ORIGINATION FORM

Proposed Revisions to a Standard Plans Index
(Please provide all information — Incomplete forms will be returned)

Index Number: 521-610
Sheet Number (s): 1
Index Title: Concrete Barrier/Junction Slab - Wall Coping

REVISION 11/01/20	DESCRIPTION	FDOT	FY 2021-22 STANDARD PLANS	CONCRETE BARRIER/JUNCTION SLAB - WALL COPING	INDEX 521-610	SHEET 1 of 3
----------------------	-------------	------	------------------------------	---	------------------	-----------------

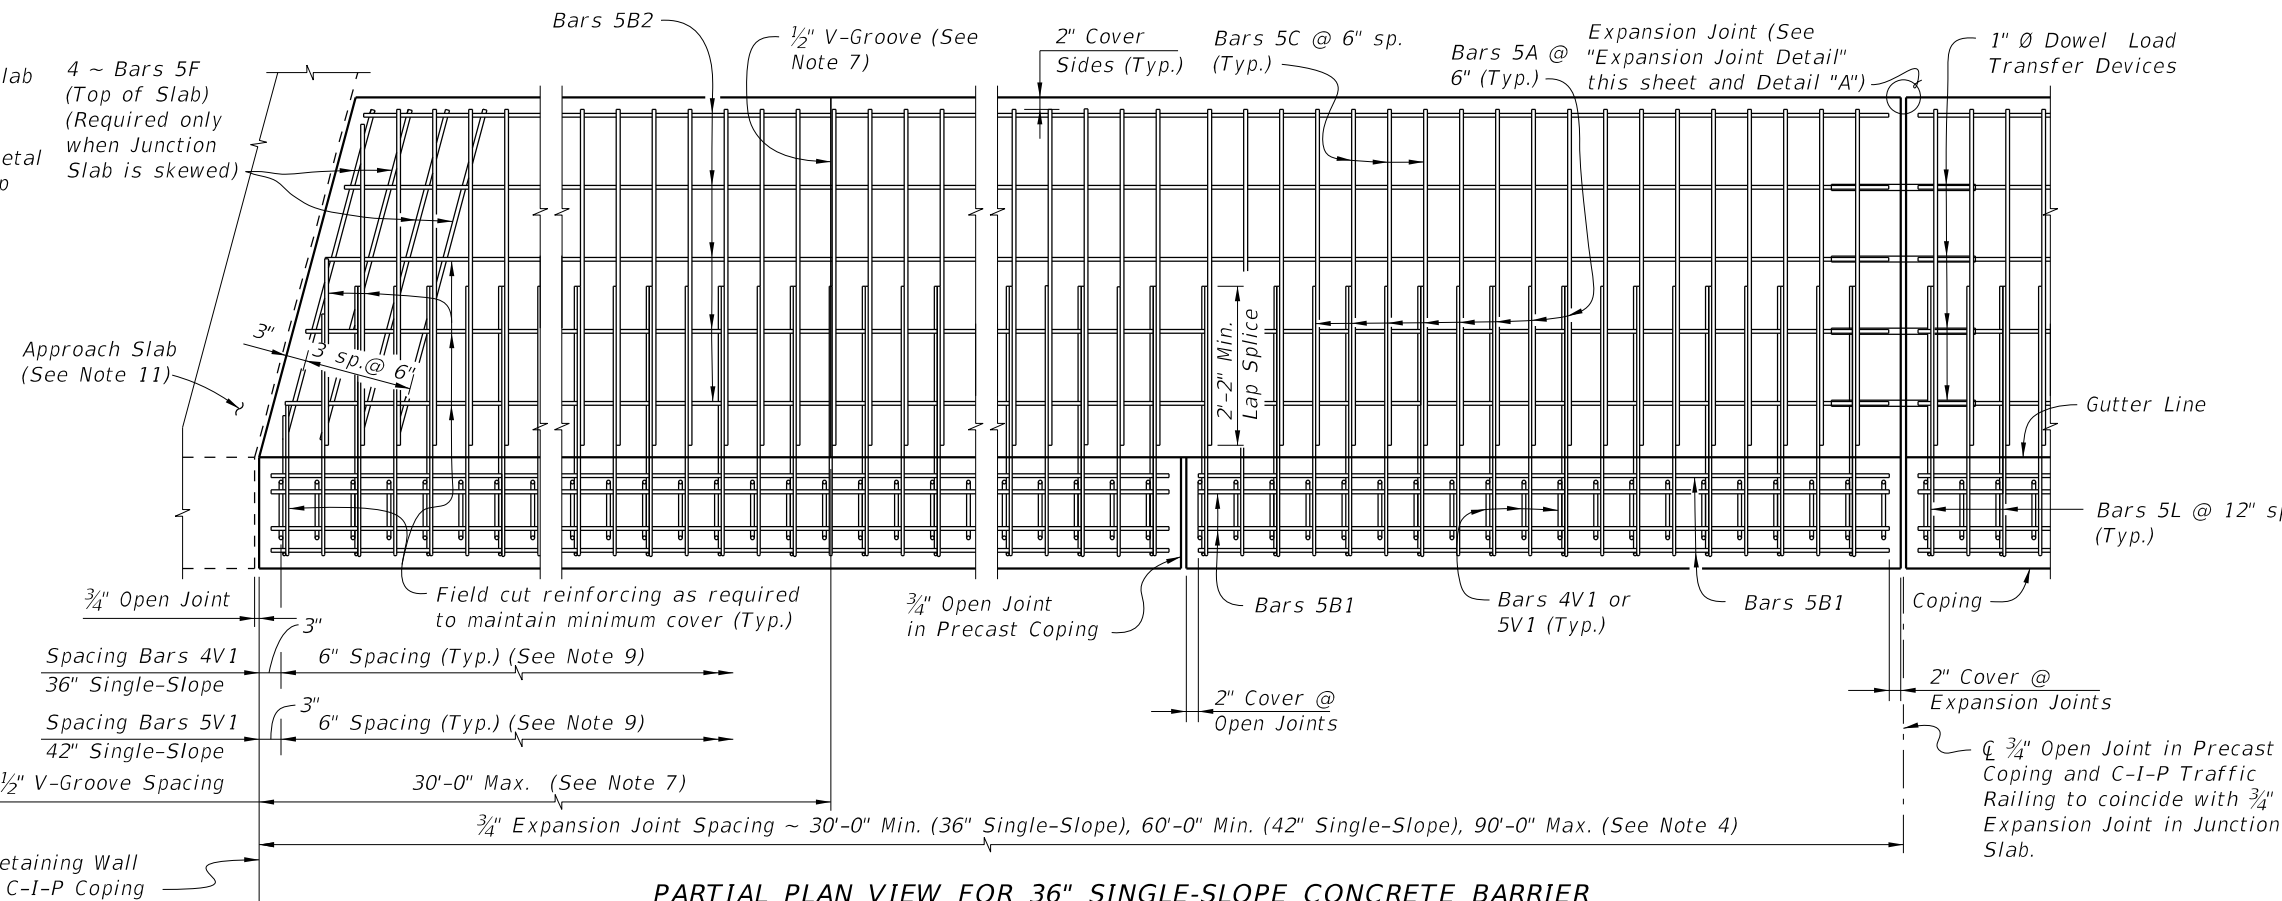
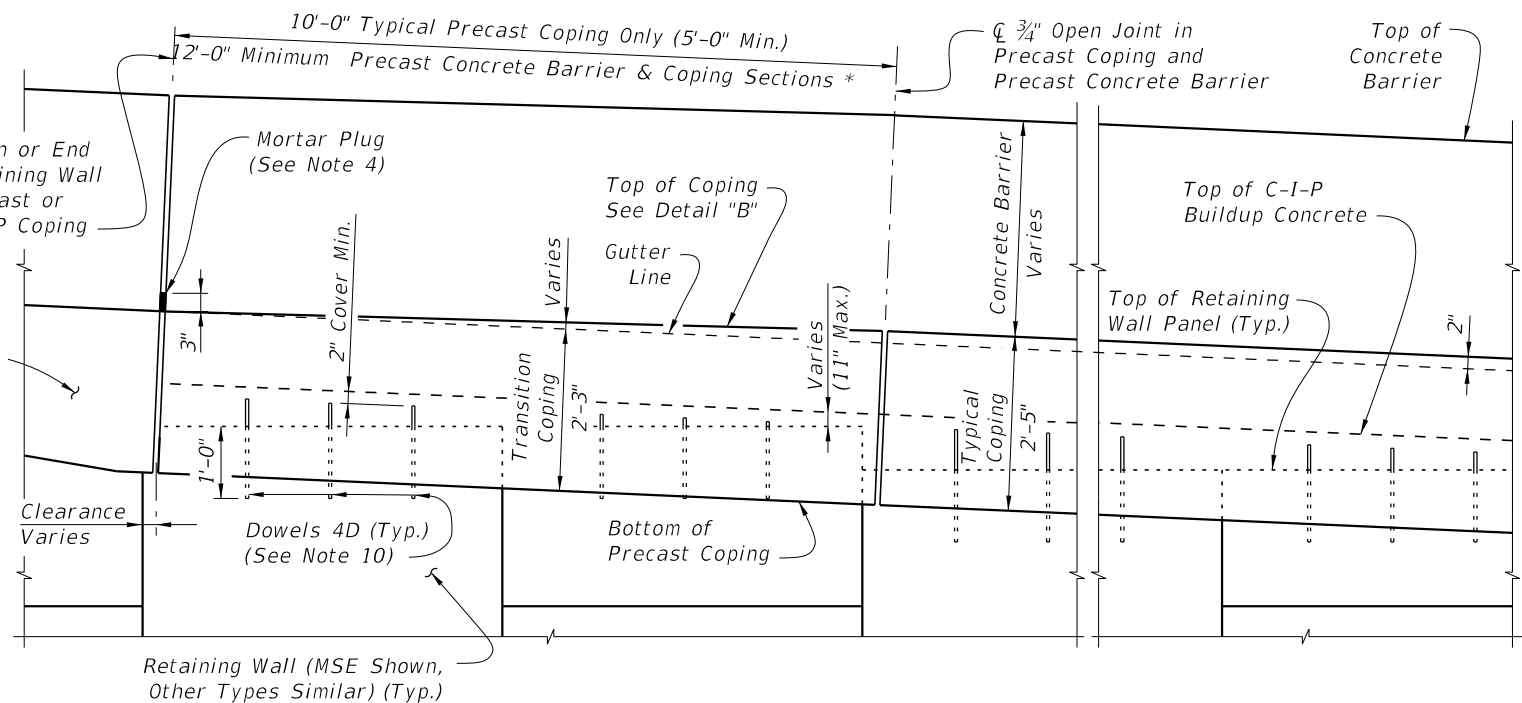
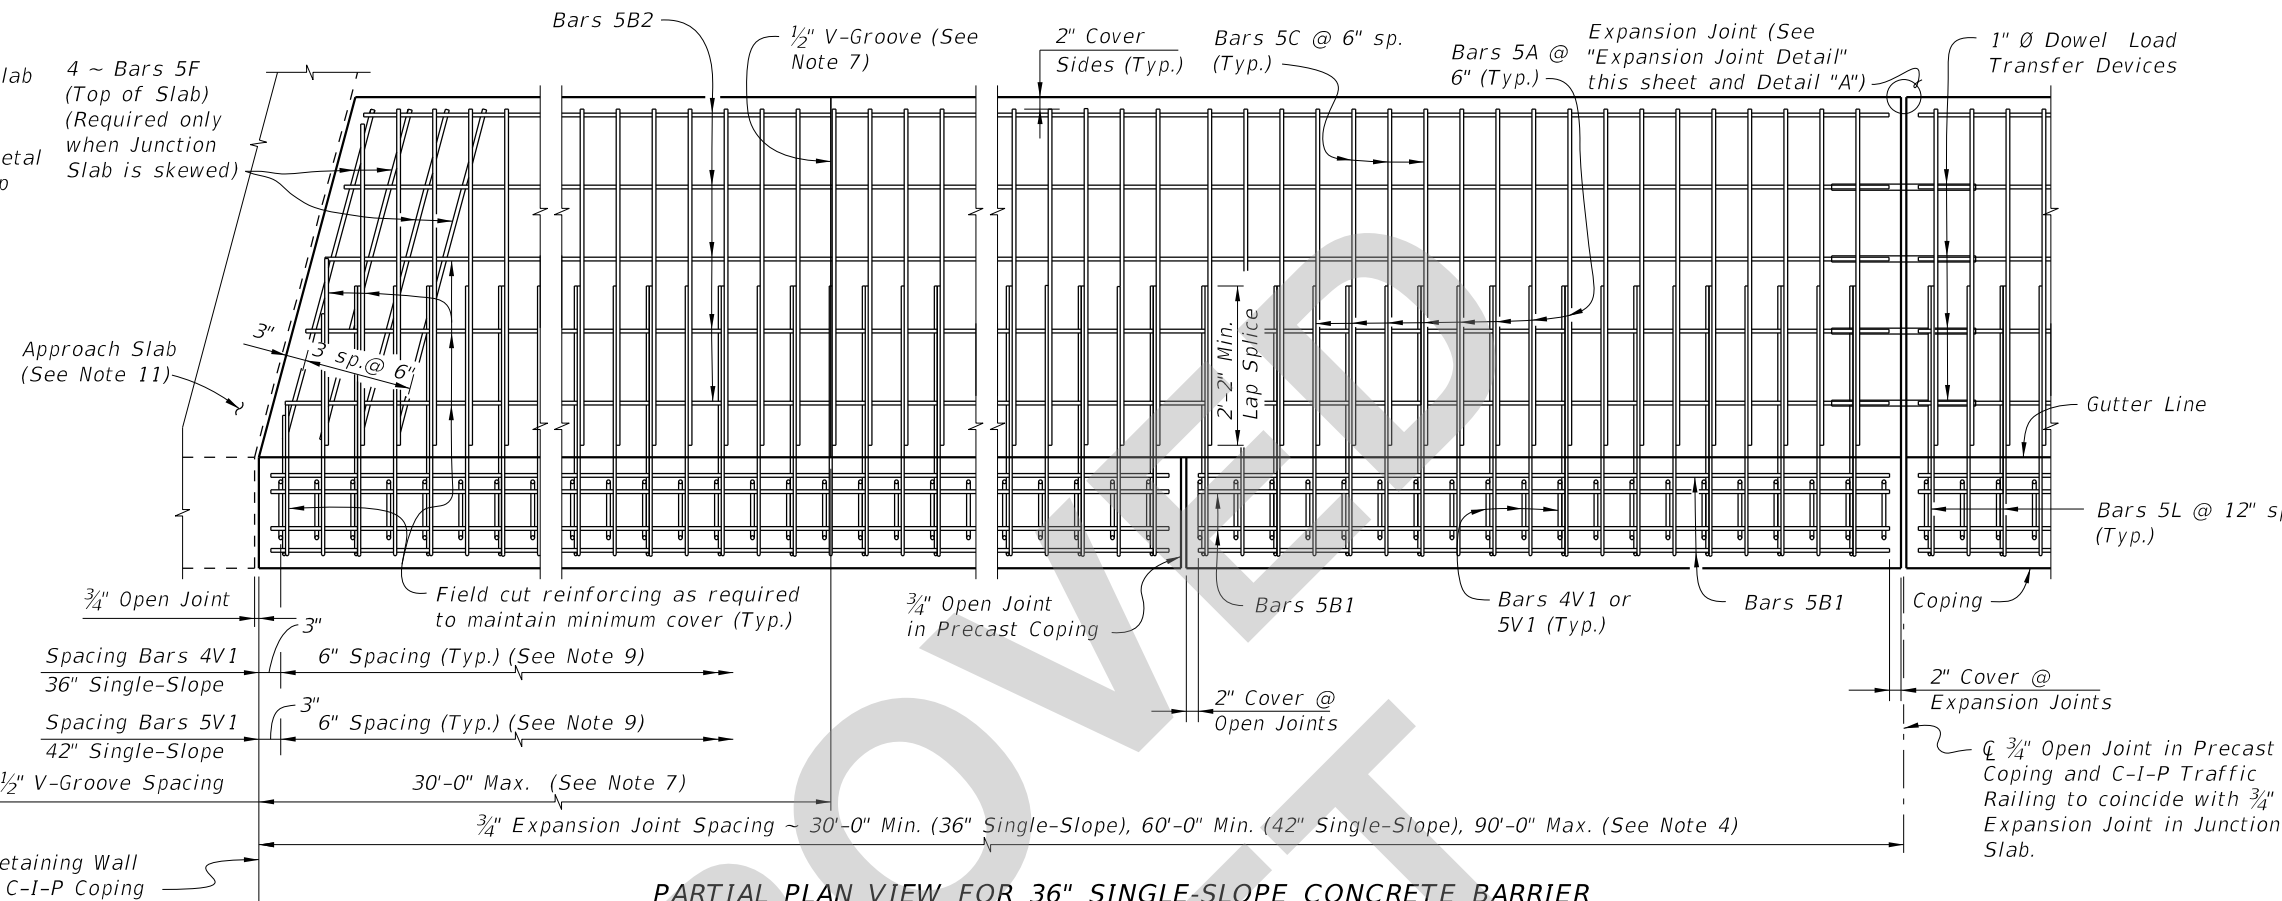
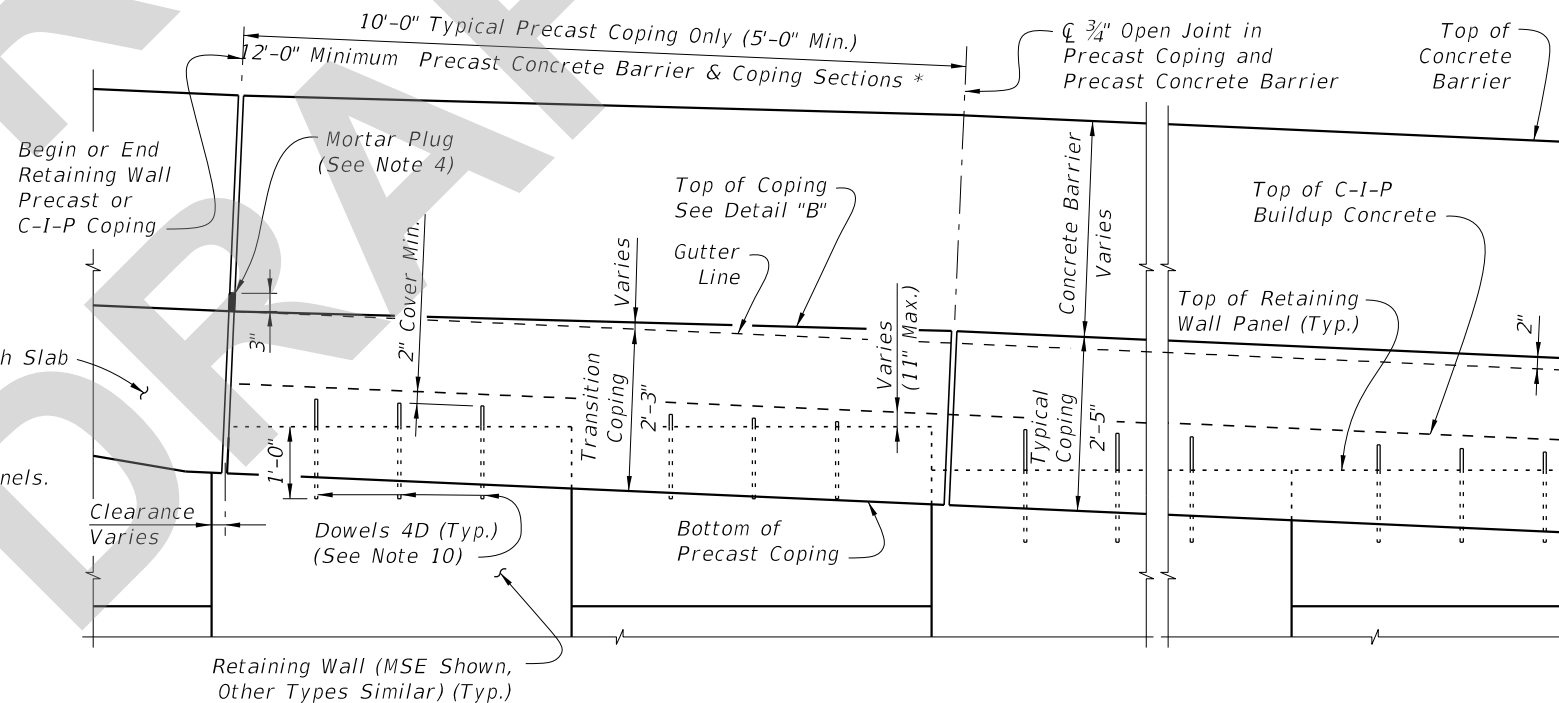
Sheet 1, Note 15: Added reference to Index 630-001 (Conduit Details - Embedded) for information on embedded junction boxes and conduits.

Added reference to provide continuity between Standards and improve understanding for designers and contractors wanting to verify that these Indexes share details. This particular topic received designer questions. This is consistent with the Traffic Railing standards.

15. For embedded conduit and junction boxes, see Index 630-010.

- For embedded conduit and junction boxes, see Index 630-010.
